Access Compliance Report

Public Rights-of-Way

(Curb Ramps)

Intersection ID: 46369	Main Street: DIXIE_HILLS_DR	Cross Street: ROYAL_CASTLE_CT	Location: NE
ADA ID: B3BB865472EB	Ramp Type: PerpDiag	Initial Pass/Fail: Fail	Overall Compliance: No
Codes/Mitigation Info/Possible Solution		Field Measurements/Component Compliance

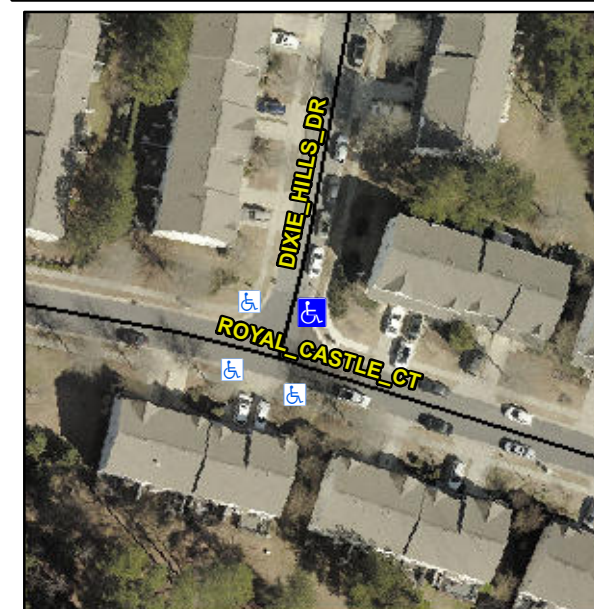
Not Found, R304.5.1, R304.5.3

Compliance	Description	Data	Compliance	Description	Data
N/A	Ramp Length (in)	96.0	Yes	Ramp Slope (%)	5.3
No	Ramp Width (in)	43.5	No	Ramp XSlope (%)	7.4
N/A	Flare Type LT	N/A	N/A	Flare Type RT	N/A
N/A	Flare Slope LT (%)	N/A	N/A	Flare Slope RT (%)	N/A
N/A	Flare Traversable LT?	N/A	N/A	Flare Traversable RT?	N/A
N/A	Landing Length (in)	N/A	N/A	DWS Provided?	N/A
N/A	Landing Width (in)	N/A	N/A	DWS Contrast?	N/A
N/A	Landing Slope (%)	N/A	N/A	DWS Length (in)	N/A
N/A	Landing X Slope (%)	N/A	N/A	DWS Full Width?	N/A
N/A	Landing Curb? (Y/N)	N/A	N/A	DWS Offset (in)	N/A
N/A	Shared Landing?	N/A			
N/A	Gutter Ponding?	N/A	N/A	Gutter Slope (%)	N/A
N/A	Gutter Lip Ht (in)	N/A	N/A	Gutter X Slope (%)	N/A
N/A	Painted X Walk1?	No	N/A	Painted X Walk2?	No
	X Walk 1 Direction	To NW		X Walk 2 Direction	To SW
N/A	X Walk 1 Width (in)	N/A	N/A	X Walk 2 Width (in)	N/A
	X Walk 1 Slope (%)	4.9		X Walk 2 Slope (%)	2.7
	X Walk 1 X Slope (%)	3.0		X Walk 2 X Slope (%)	5.4

Remove & Replace Curb Ramp With Two New Directional Ramps or Equivalent.
